(Sling Aircraft (Pty) Ltd. considers compliance with all Service Bulletins mandatory)

RELEASE DATE:	14/06/2024
EFFECTIVE DATE:	08/07/2024
SUBJECT:	Inspection and possible replacement instructions of the Sling 4 TSi seatbelt shoulder guide anchor bolts.
MODELS AFFECTED:	All Sling 4 TSi aircraft, up to (and including) SN 584.
COMPLIANCE TIME:	Next MPI (Mandatory Periodic Inspection) or annual inspection, whichever comes first.
LABOUR TIME:	45 minutes

Figure 4: Correct bolt installation.

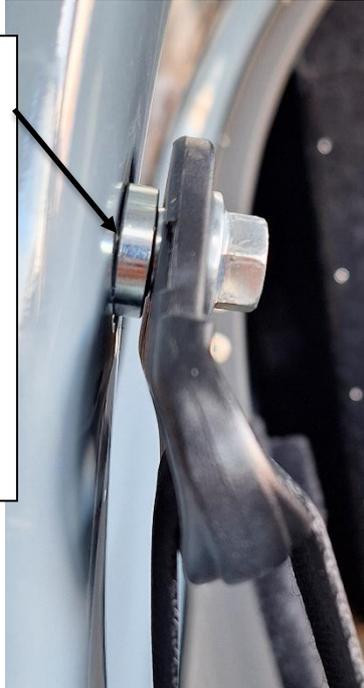
Step 2: Ensure the bolt and spacer are installed correctly, the spacer should fit flush with the composite canopy. The shoulder of the bolt presses up against the spacer (this can be seen in Figure 4 and when tightened compresses the spacer to the canopy). The correct installation can be seen in Figure 4, the incorrect installation can be seen in Figure 5. If the issues shown in Figure 5 are present in the installation, the bolt may not be screwed in all the way. **Do not** force the bolt into the hole, there may be debris on the nut's thread which need to be removed using a thread tap. This will be explained in Sections 3.3 and 3.4. It is also possible that the dog point of the bolt may be pressing up on the composite behind the nut. The bolts supplied with the service bulletin kits have this tip removed and will not cause interference.

The bolt is fully tightened such that the bottom of the shoulder sits against the spacer, and that the spacer sits flush with and compressed against the canopy inside skin.

Figure 5: Incorrect bolt installation

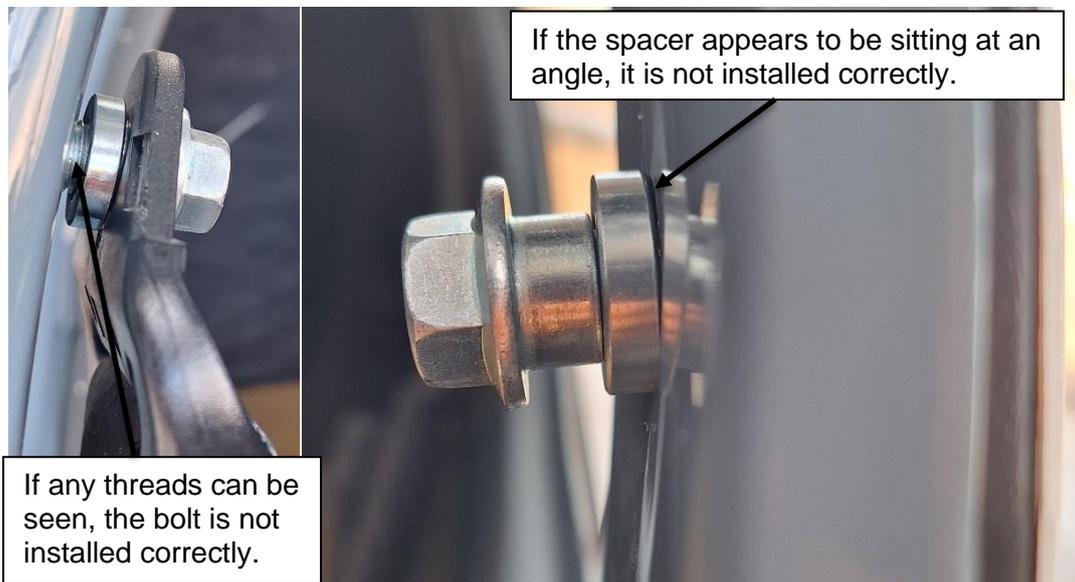
If any threads can be seen, the bolt is not installed correctly.

If the spacer appears to be sitting at an angle, it is not installed correctly.

Figure 6: Seatbelt shoulder bolt installation location

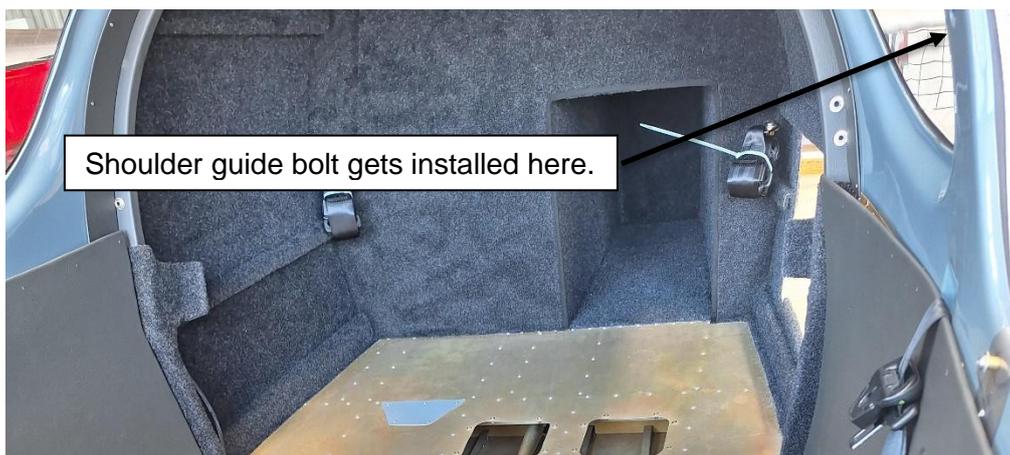
- Step 1: Due to the manufacturing process, there is a potential for contaminants to be present on the thread of the hole that the shoulder bolt of the seatbelt screws into. Due to this, the threads need to be inspected, and are to be free and clear of any debris (such as weld splatter, paint, resin etc.). These will be present on both the left- and right-hand side of the cockpit. Figure 6 shows the location of the hole on left side of the cockpit.

- Step 2: If there is debris present on the thread of the hole, an M11 tap must be used to clean the threads of the hole.
- Step 3: Once the holes have been tapped, the threads must be reinspected to ensure they are free of debris.
- Step 4: Once the holes are free of debris, install just the shoulder bolt and spacer as depicted in Figure 8.

Figure 9

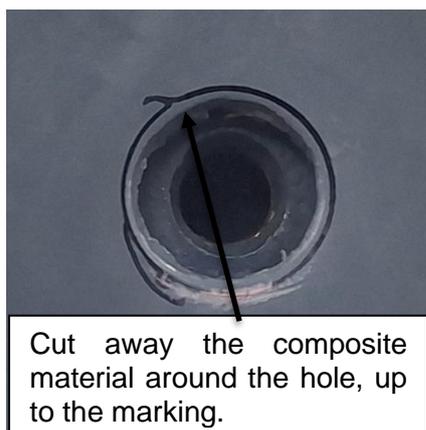
Step 5: After the bolt and spacer have been installed, use a permanent marker and draw a line around the spacer, as seen in Figure 9.

Step 6: Remove the bolt and spacer and use a Dremel or a file to sand away the composite up to the marking, that was made around the spacer. This hole should now be wide enough for the spacer to pass through the composite and sit flush on the mounting plate that is bonded into the canopy.

Figure 11: Seatbelt shoulder guide installation

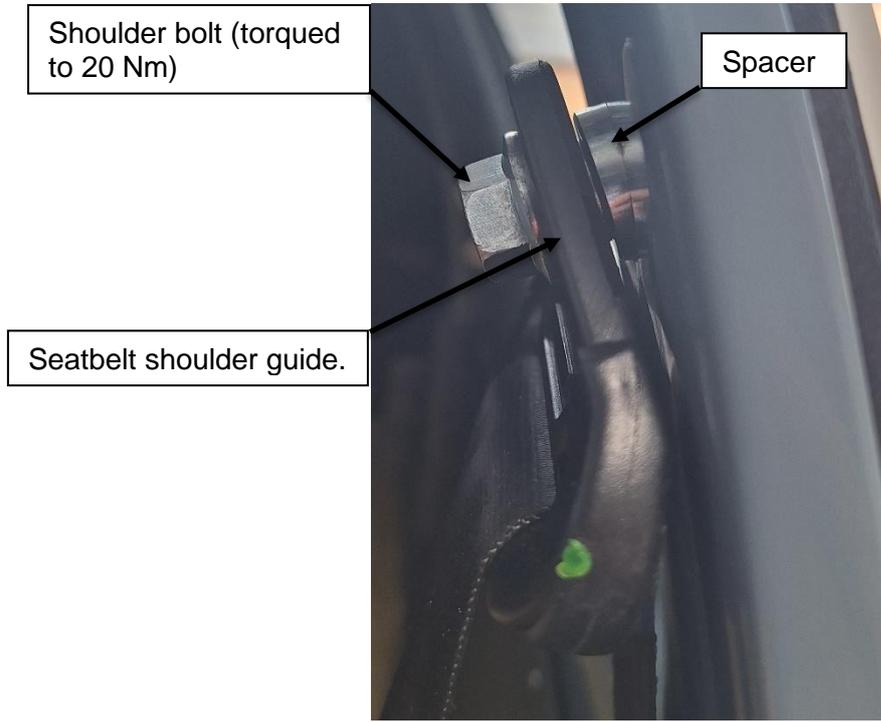
Step 7: Once the cutout has been widened, install the bolt, spacer and shoulder anchor guide of the seatbelt as seen in Figure 11. Ensure that the spacer fits through the cutout and is able to locate on the mounting plate that is bonded into the canopy. Loctite 243, or an equivalent, should be used on the bolt thread to ensure it does not unscrew on its own. Torque the bolt to 20 Nm.

Figure 15: Seatbelt shoulder guide installation

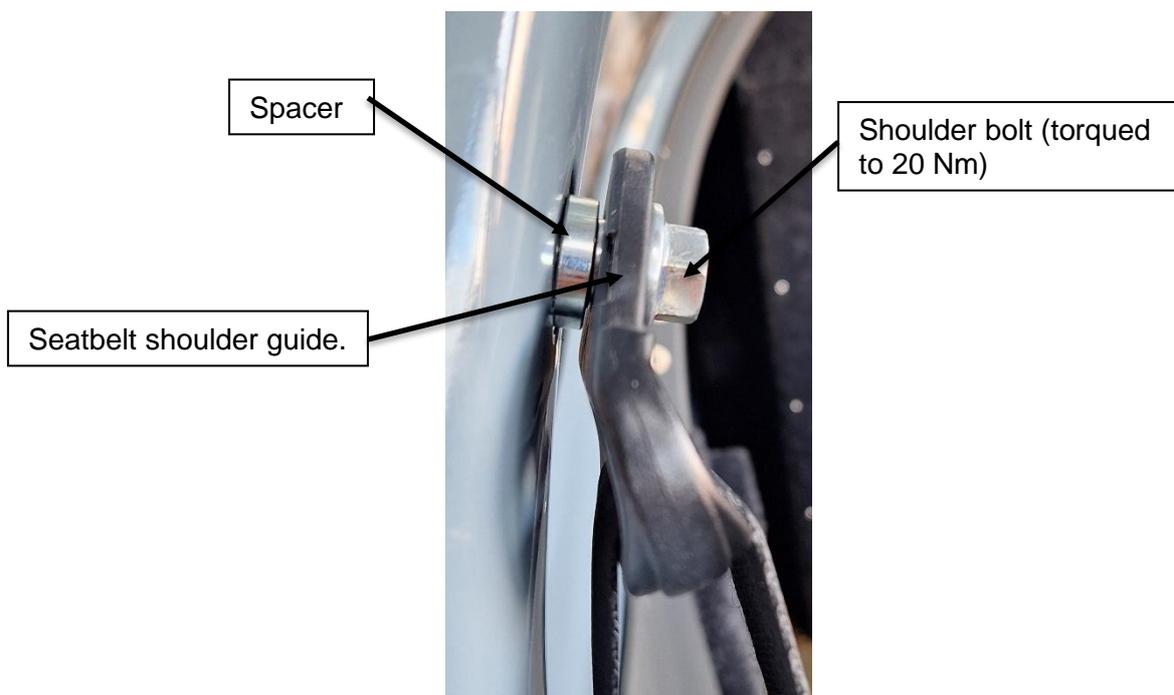
Step 4: Install the bolt, spacer and shoulder anchor guide of the seatbelt as seen in Figure 15. Loctite 243, or an equivalent, should be used on the bolt thread to ensure it does not unscrew on its own. Torque the bolt to 20 Nm.
